Project Title: Tiburon Heights Subdivision Building Permit #: _____ City Drainage #: D10 / D03A
DRB#: 1009178 EPC#: _____ Work Order#: 790681
Legal Description: Tiburon Heights
City Address: Petirrojo Road NW

From: Harmon Rita T. <rharmon@cabq.gov>
Sent: Monday, August 24, 2015 3:51 PM
To: Diane Hoelzer
Subject: RE: Tiburon Heights

PROJECT TIBURON HEIGHTS
SUBJECT Drainage Calculations
BY DLH DATE 9-14-15
CHECKED _____ DATE _____
SHEET 1 OF _____

**RE: Tiburon Heights
Grading and Drainage Plan
Engineers Stamp Date 11/26/14 (D10D03A)
Certification Date 7/31/15**

DWG. 2205

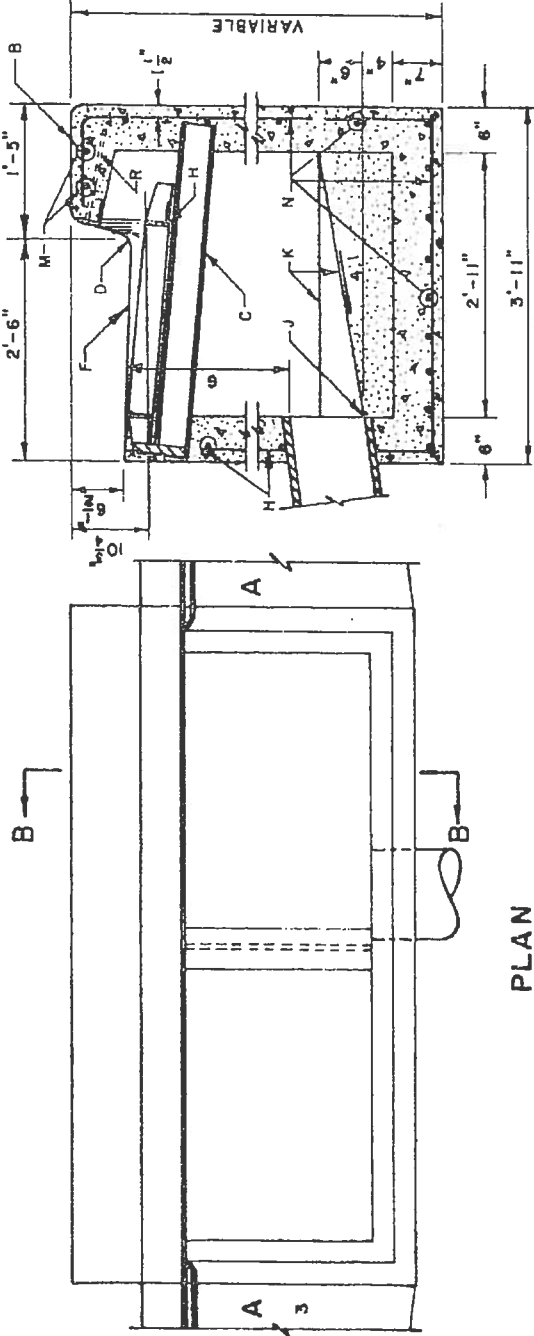
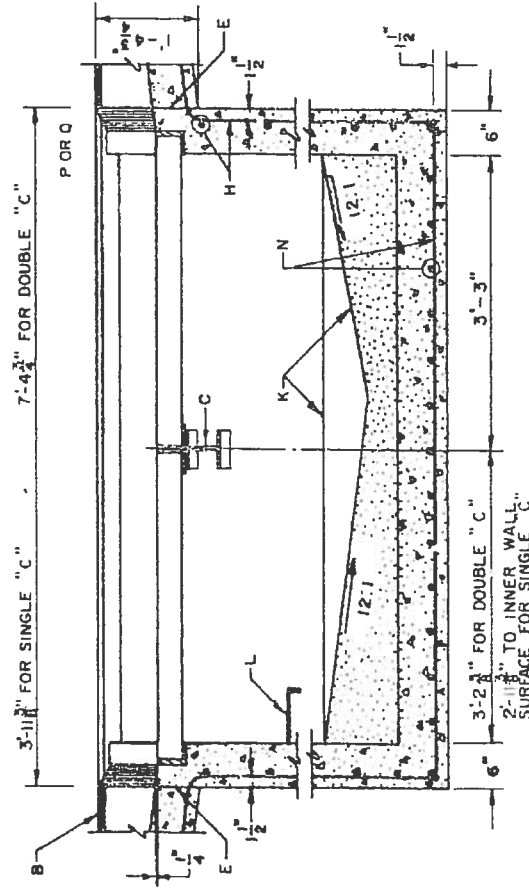
CALCULATE CAPACITY OF SINGLE "C" INLET.

$Q_{\text{TOTAL}} = 13.0 \text{ cfs}$ CAPACITY AT TOP OF CURB

$$13.0 > 10.7$$

TIBURON HEIGHT
Typical Lot Layout - 9-14-15
Typical Minimum Offsets

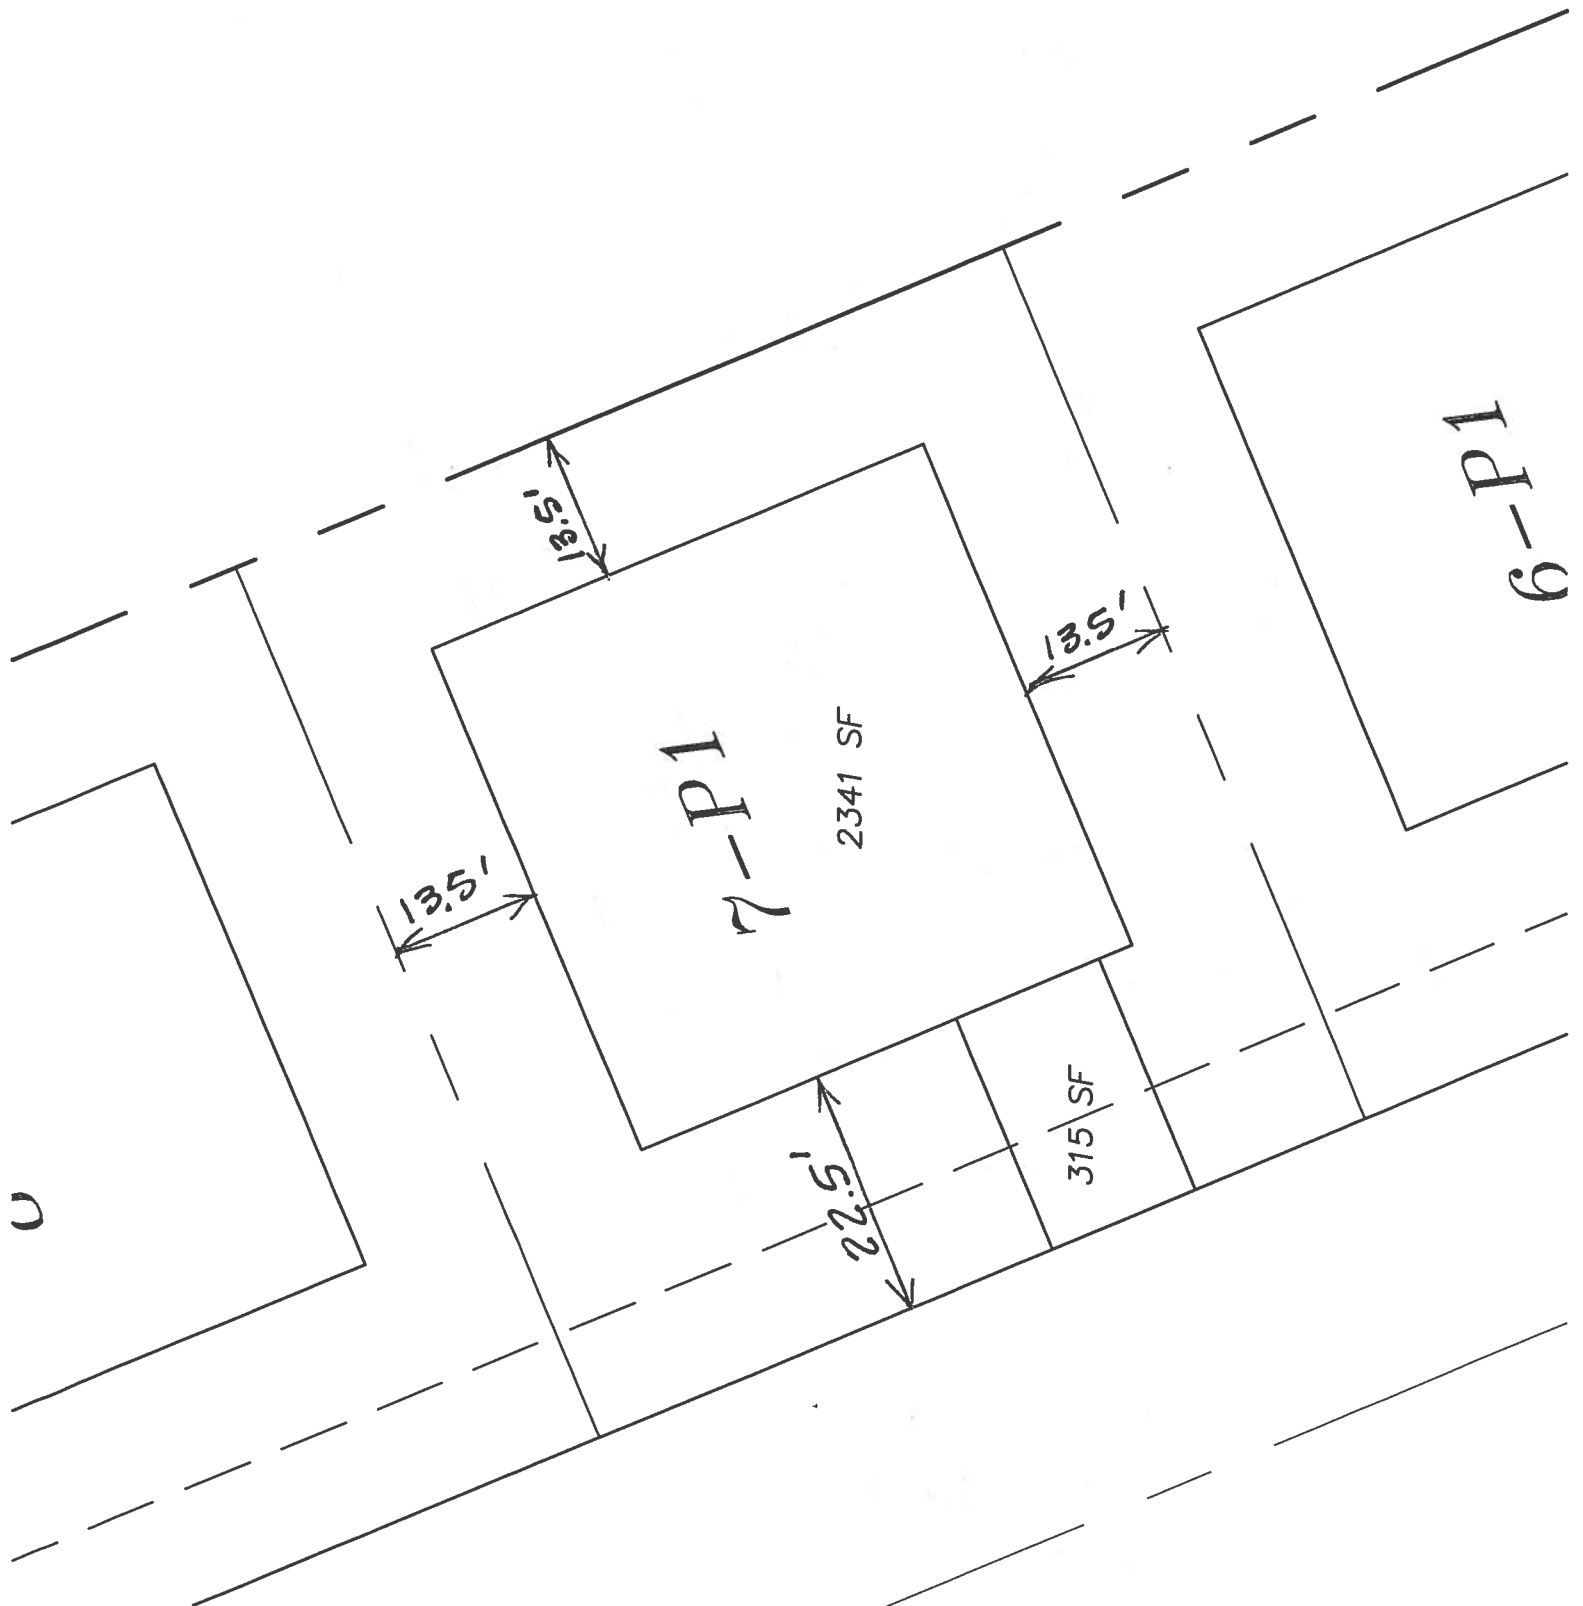
No, for the entire subdivision. I am trying to get an idea of how much "actual" discharge is being generated by the subdivision, as compared to that determined by using the formula. Then we can compare it to that %D used to size Pond #5. Do you see where I am going with this? Checking to be sure Pond #5 has capacity for the increase in %D.

Please compare the impervious area calculated using the DPM formula from Table A-5, and the scaled impervious area using the proposed offsets.

COMPARE TABLE 5 (DPM) W/ TYPICAL PLOT PLAN LAYOUT

$$\text{IMPERVIOUS AREA} = 2656 \text{ SF (42\%)}$$

$$\text{Treatment D} = \frac{177,137 \text{ SF}}{344,716 \text{ SF}} = 51\%$$

∴ INCREASE FROM 49% TO 51%
